Ref: Response to request for review “Power generation from coking waste heat utilization project at Taiyuan City Wanguang Coal and Coking Co., Ltd in Shanxi, China” with the Reference Number 1725

01 August 2008

Attention: CDM Executive Board

Figure 1: Sensitivity analysis production capacity design rate

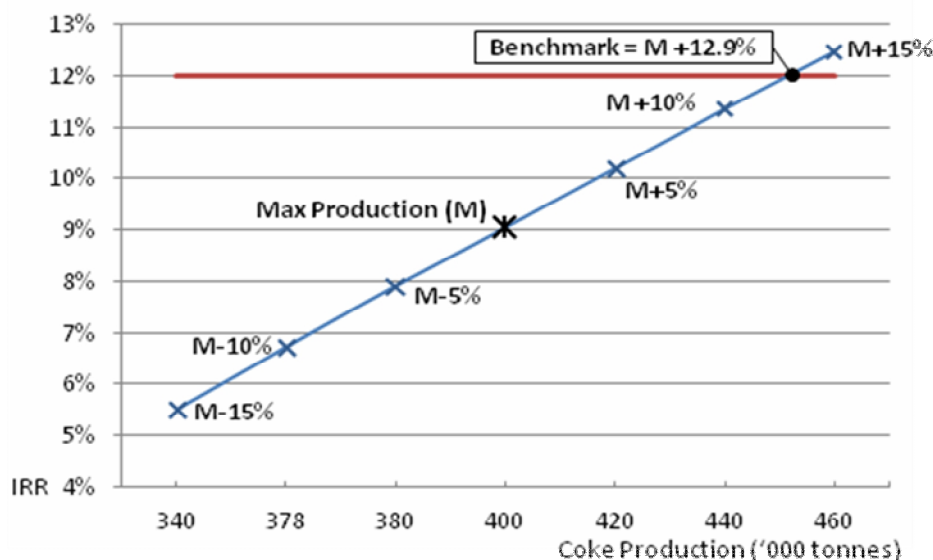
The PP/DOE shall provide information on the maximum and minimum production capacity design rate of the coke production and apply these values to the sensitivity analysis

A sensitivity analysis on the maximum coke production has been included in the updated spreadsheet previously submitted to the DOE. **Figure 1** shows the results of the sensitivity analysis.

The IRR of the project exceeds the benchmark in the scenario that coking production reaches 12.9% over its estimated maximum production capacity. This result meets the general point of departure as outlined in the EB’s *Guidance on the assessment of investment analysis* which suggests that variations in the sensitivity analysis should at

In conclusion it is therefore unfeasible that realized coke production would exceed the maximum capacity design rate by 12.9%. Apart from that this would contradict the FSR and relevant approvals, such a large variation for a facility of this type and size would be unlikely. The amount of power generated is also restricted by the design of the power generation facility.

Figure 2: Detailed Project Implementation Timeline

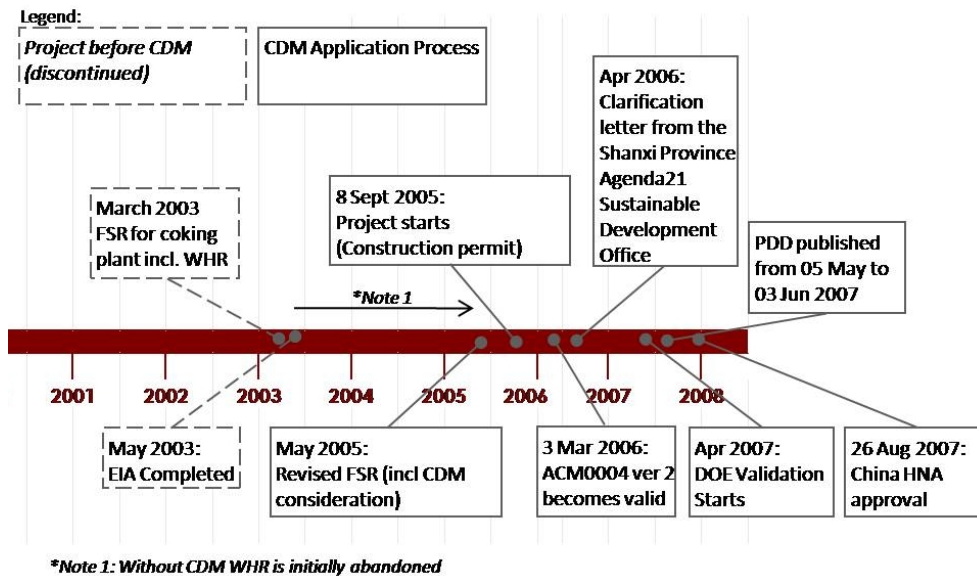
The DOE is requested to provide an explanation for the delay in submitting the project for validation to show that CDM revenues were considered essential in the decision to invest in the project activity. The response should provide a detailed timeline of project implementation with relevant, preferably third-party, evidences of the serious prior consideration of CDM.

A detailed timeline of the project implementation is provided in **Figure 2**. This timeline has been validated by the DOE.

During initial development of the coking facility a feasibility study was undertaken in March 2003 to determine the feasibility of a waste heat recovery plant at the coking facility. Ultimately it was decided by the project owner not to proceed with the waste heat recovery plant at this time as it was not considered a financially attractive investment. In 2005 the project owner learned of CDM and reconsidered its decision, commissioning a new feasibility study in 2005 which considered the potential benefit of CDM.

The project owner seriously considered CDM revenues for its investment decision in May 2005, basing the decision on the revised FSR. A clarification letter from the Shanxi Province Agenda21 Sustainable Development Office (under the Provincial Development and Reform Committee) dated April 2006 confirmed that the project had started the CDM application process. This letter has been validated by the DOE and is referred to in the project's validation report.¹⁸
